Project Name:	Coldharbour Farm Road, Emsworth
Document Reference:	187.0018/TN/2
Document Name:	Transport Note
Prepared By:	Mark Smith (May 2026)
Checked By:	Mark Smith (May 2026)
Approved By:	Mark Smith (May 2026)

Designers Response Road Safety Audit
Coldharbour Farm

Road Safety Audit Report

Proposed Continuation of Coldharbour Farm Road Emsworth

DISCLAIMER NOTES:

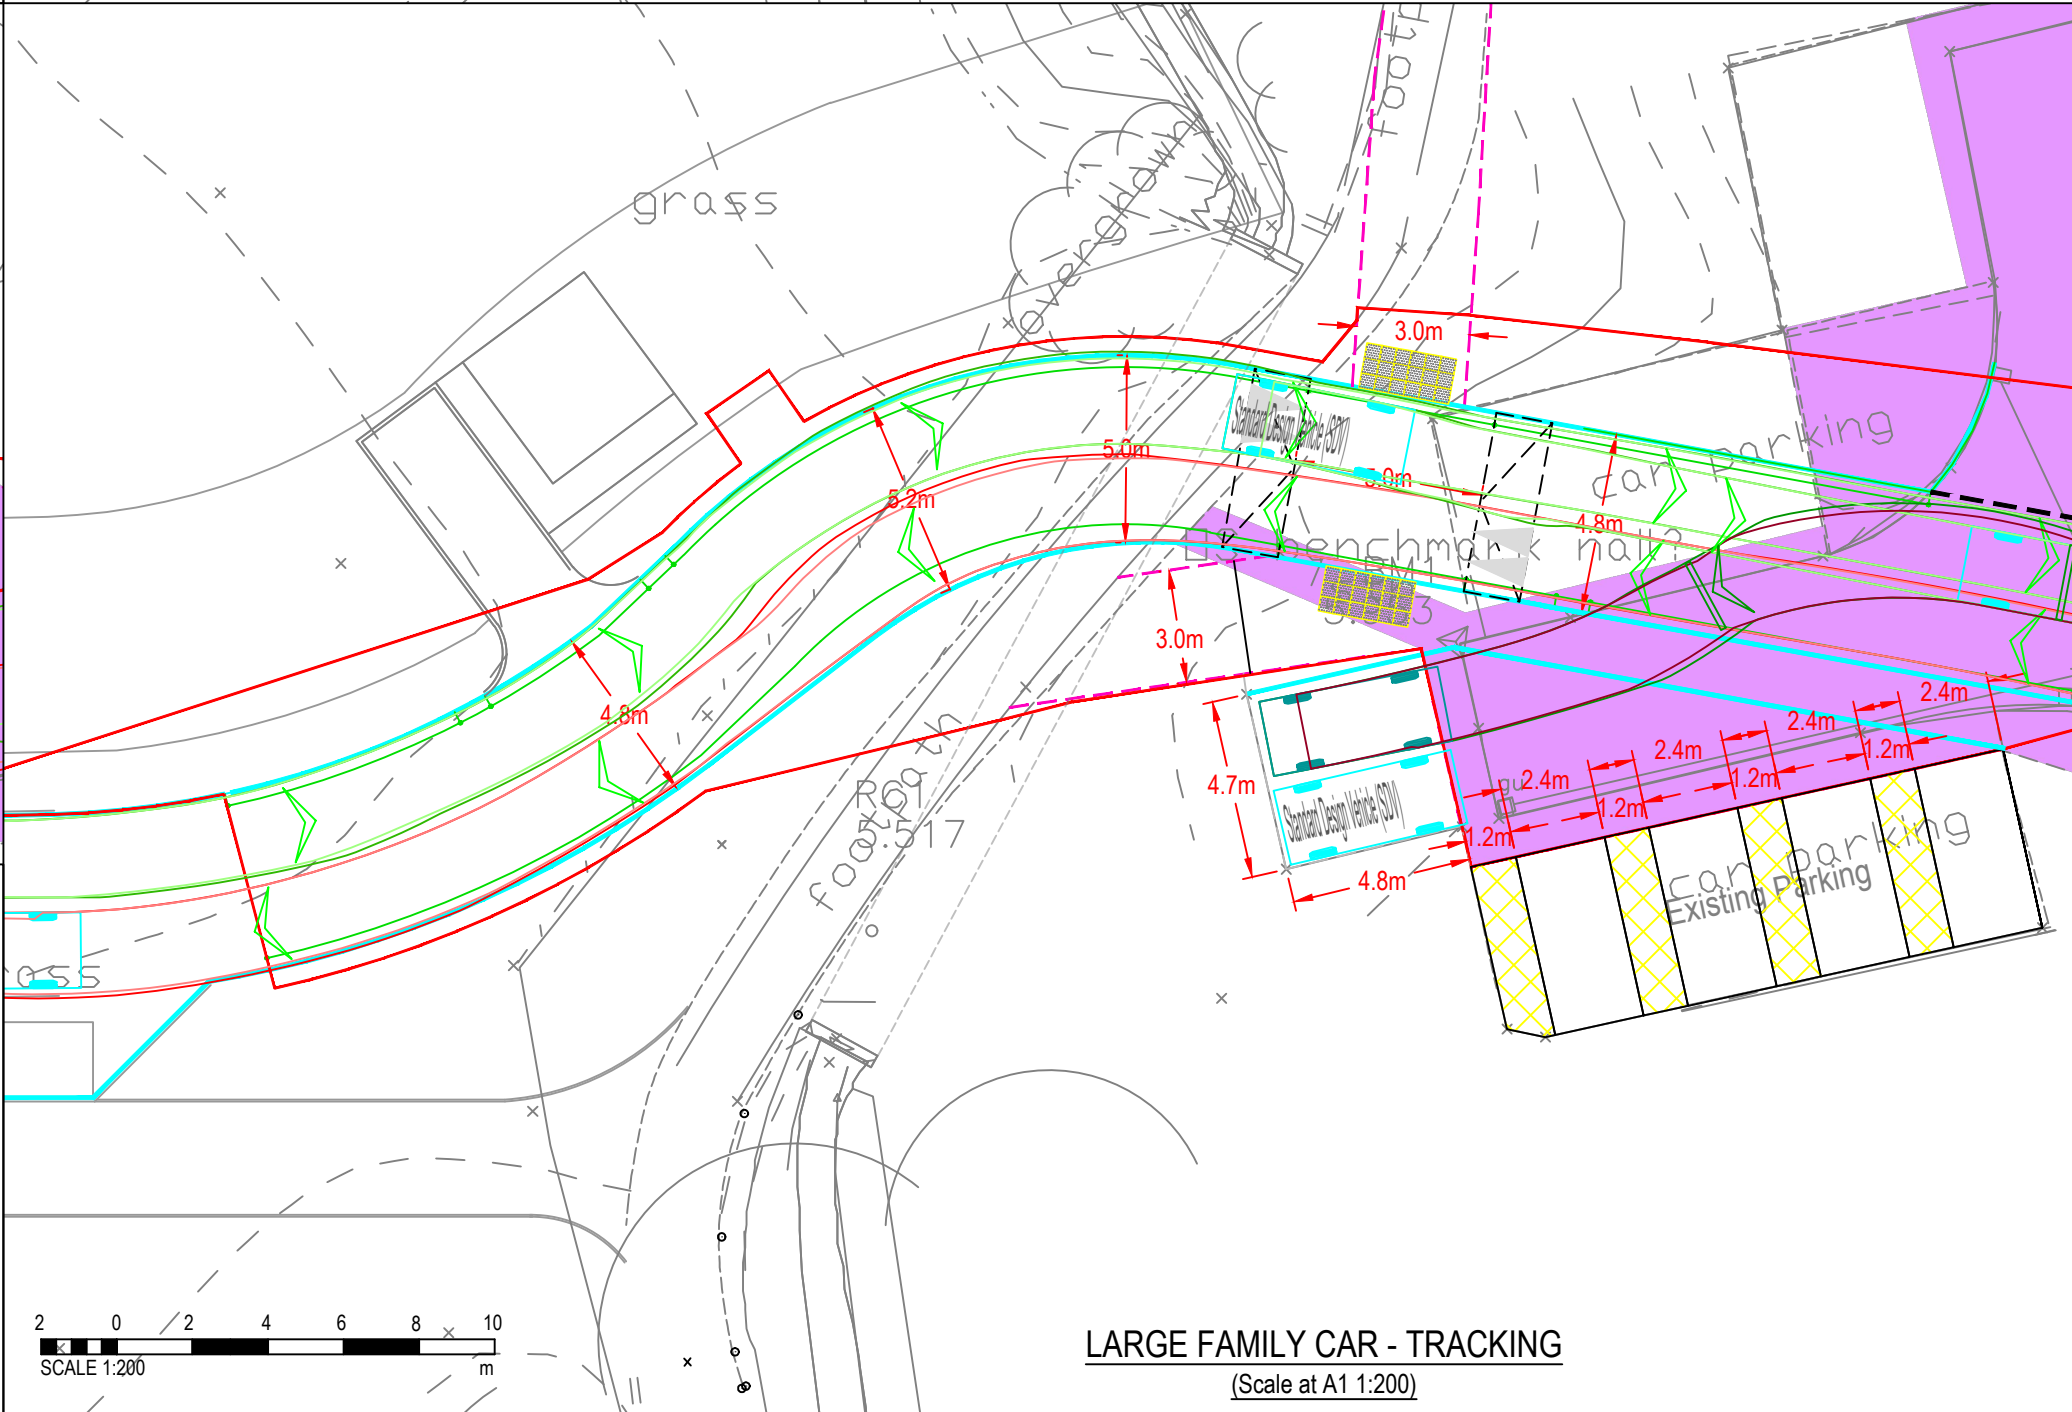
B.4.1 - Cyclists are likely to continue without giving way to traffic. It is recommended that an appropriate level of visibility is achievable.

B.4.2 - Non-motorised users at and on approach to the uncontrolled crossing may not be clearly visible during the hours of darkness. It is recommended that visibility is achievable to the tangent and that the proposed crossing point is illuminated adequately with a column provided immediately to the west of the crossing point as previously proposed.

Suitable visibility splays for cyclists are as shown on Drawing 23339-JUBB-XX-XX-DR-X-000100 REV C13. In dashed orange. With regards to lighting, this has been confirmed as suitable by the lighting designer.

Suitable visibility splays for pedestrians are as shown on Drawing 23339-JUBB-XX-XX-DR-X-000100 REV C13. In dashed yellow. With regards to lighting, this has been confirmed as suitable by the lighting designer.

DRAWING No: JUBB_XX_XX_DR_C_1200

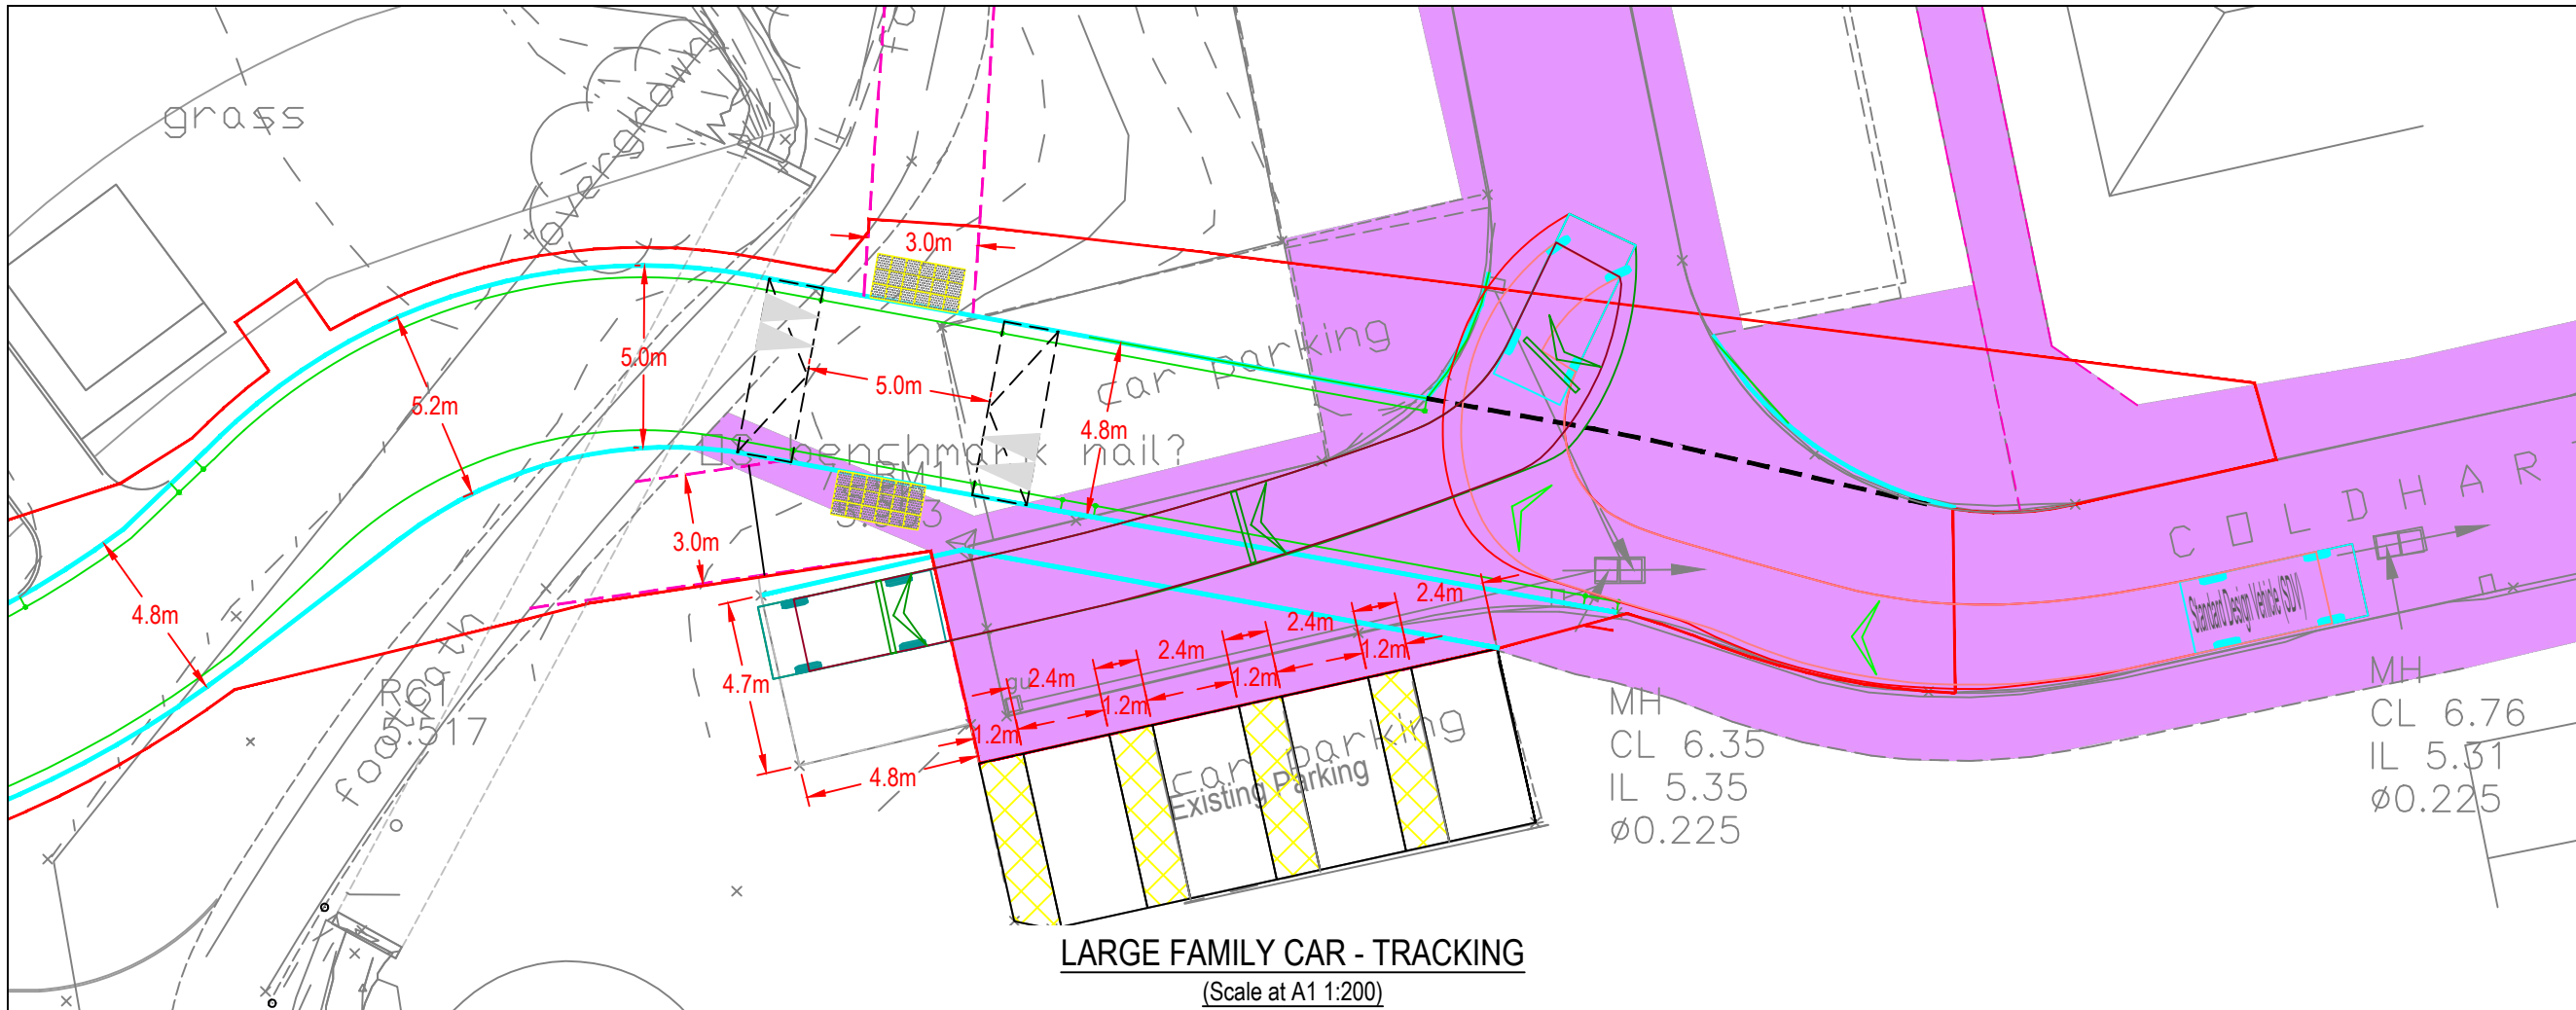
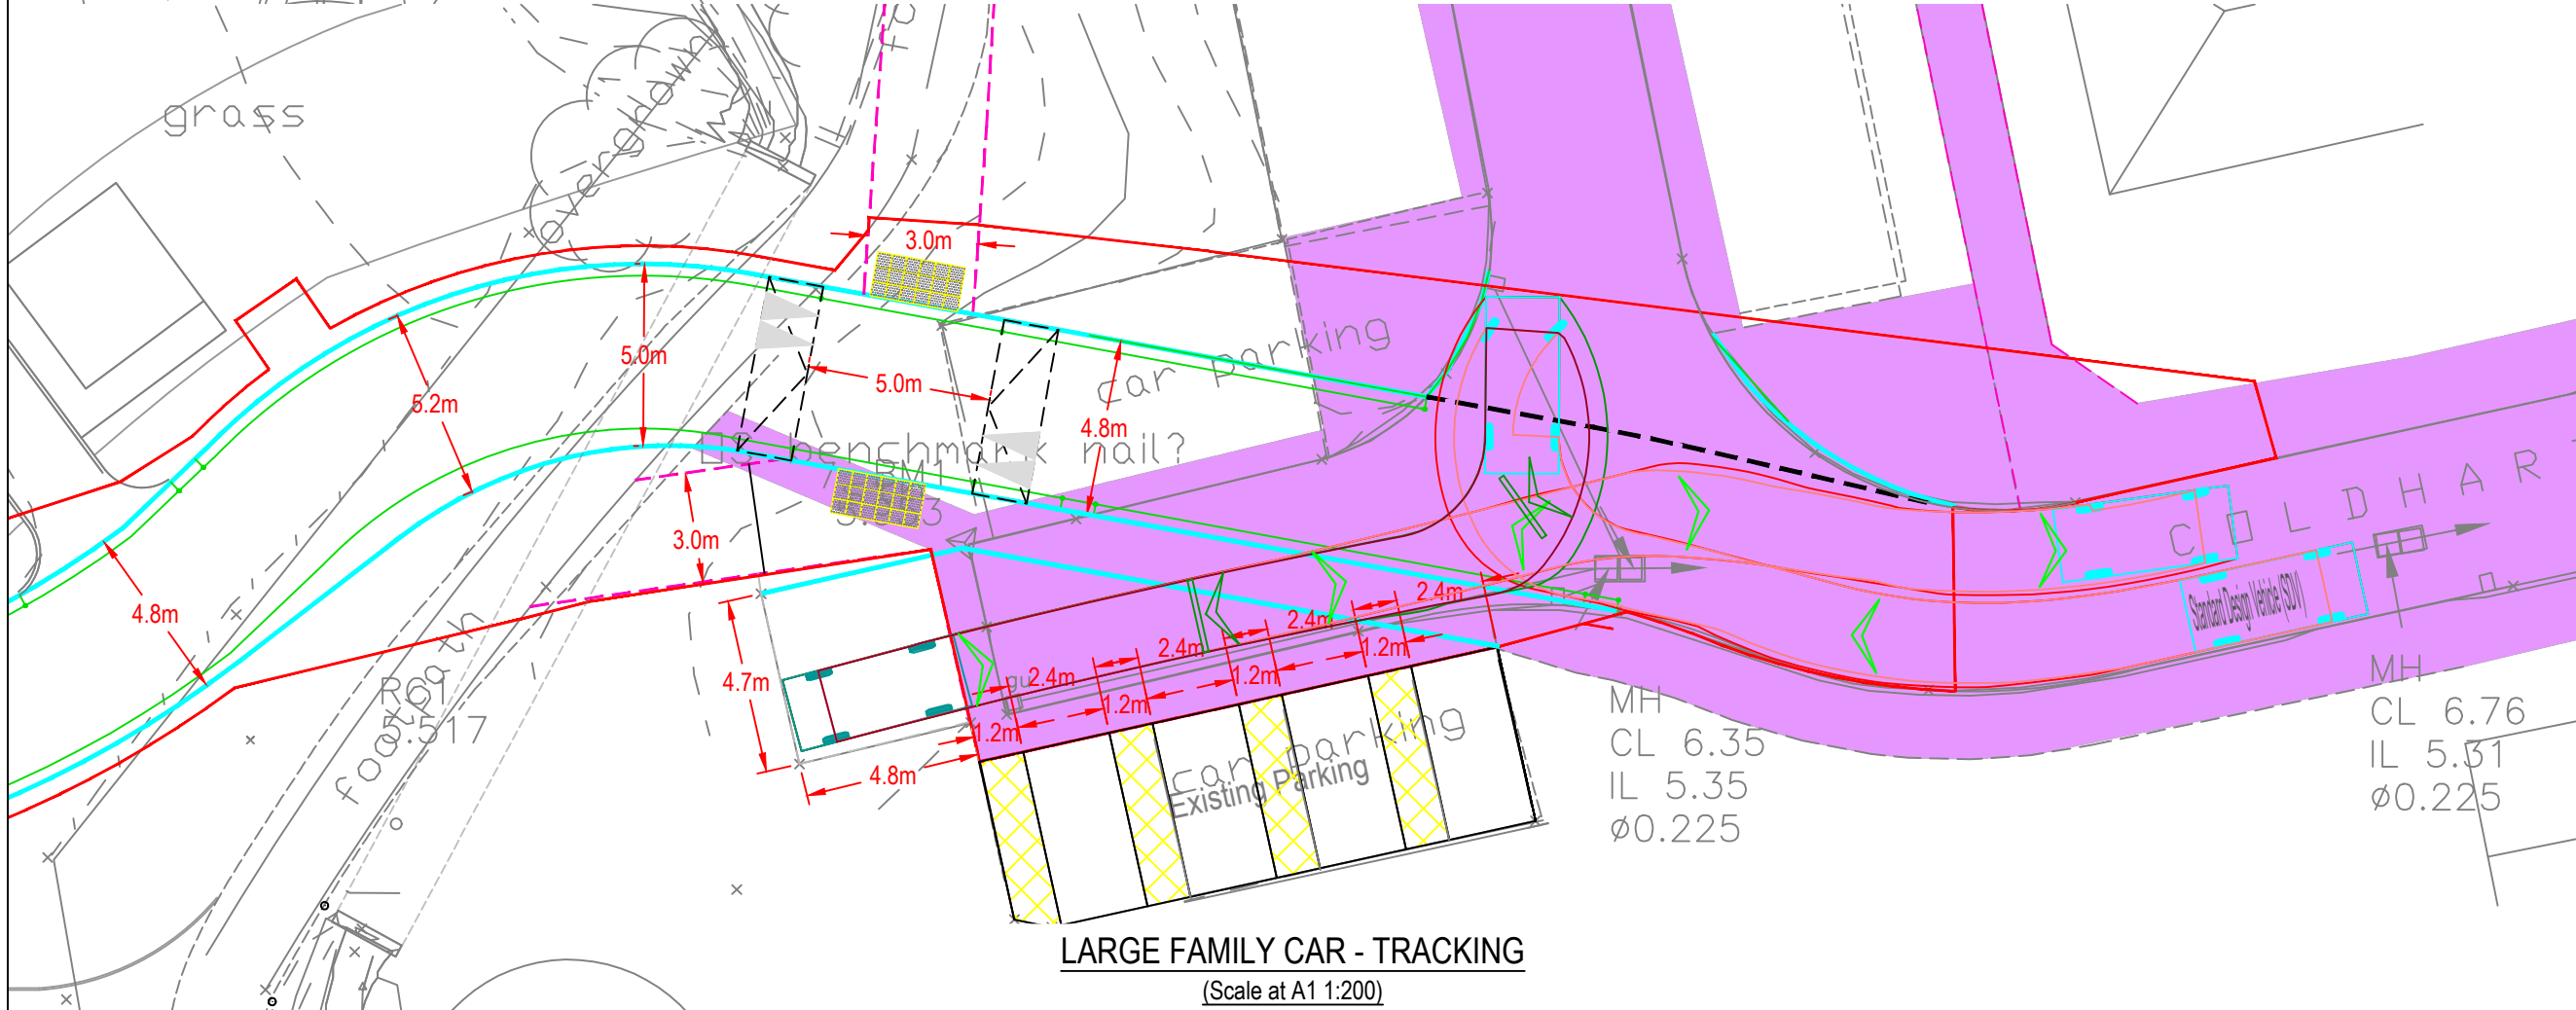
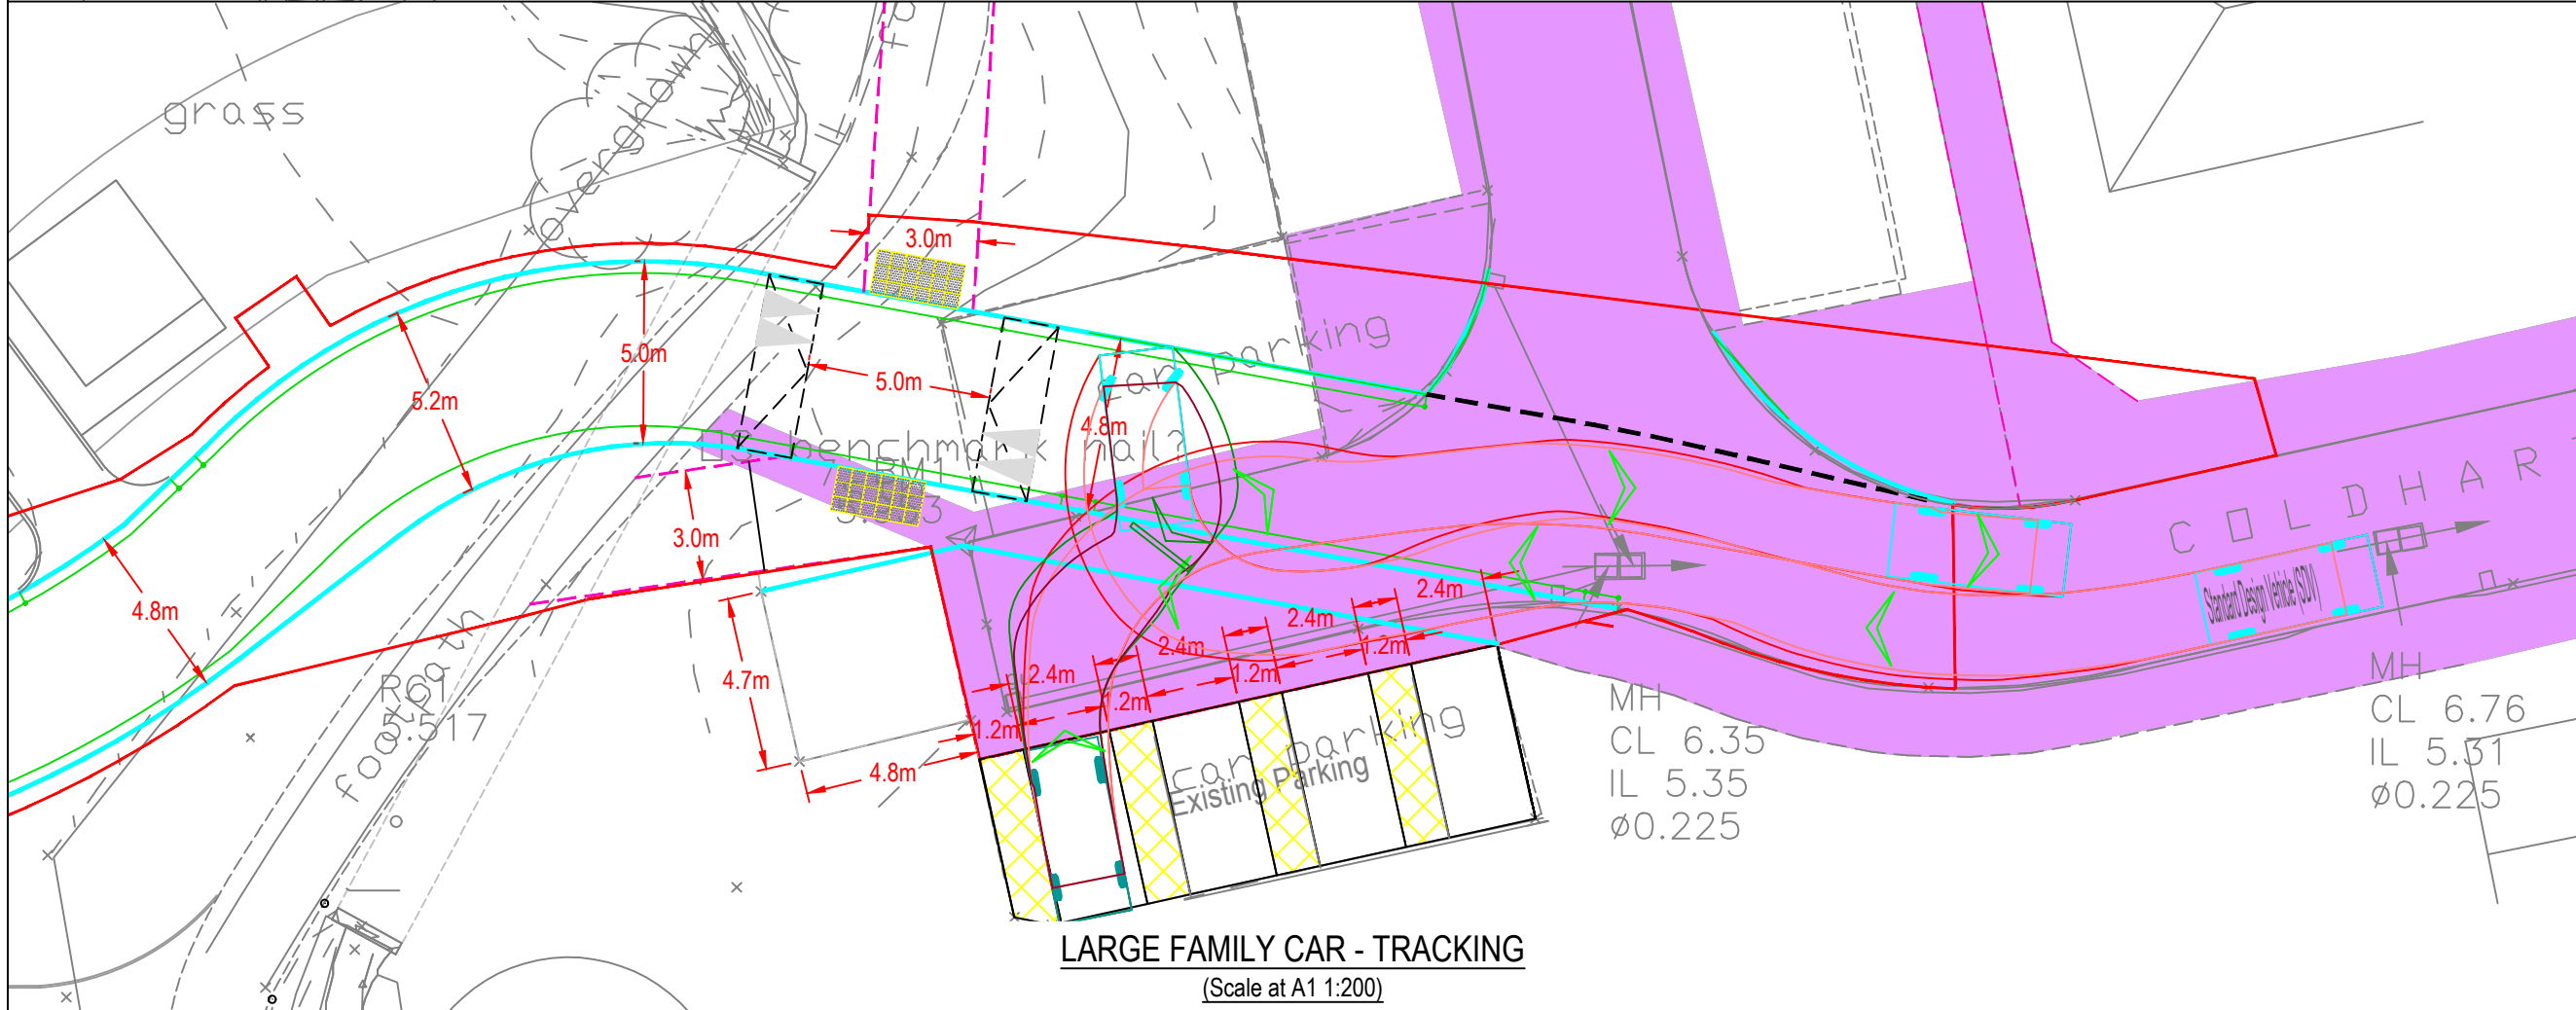
B.1.1 – Alignment may not be adequate for two-way car / LGV movements. It is recommended that the carriageway is adequate for cars and LGVs to pass one another.

We have provided updated tracking Drawing 23339-JUBB-XX-XX-DR-X-001200 REV C4 that shows in the bottom right that cars can pass each other.
